Operator: *Highpoint Operating Corp LLC*

Location Name: Anschutz Equus Farms 4-62-33 SWNW

Loc ID: 437847

Inspection: 717700338

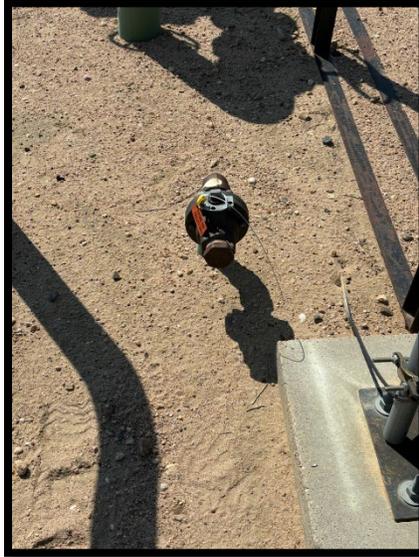
CA: Unmarked Riser, needs to be marked.. Comply with the 1100 Rules.

CA: Missing bird protector on line heater needs to be replaced. All stacks, vents, or other openings will be equipped with screens or other appropriate equipment to prevent entry by wildlife, including birds and bats.

CA Resolution: Operator has addressed the issue and future use tags have been installed on all unused risers in order to comply with the 1100 series.

CA Resolution: Operator has replaced the bird screen on the line heater in order to comply with CA order stated.
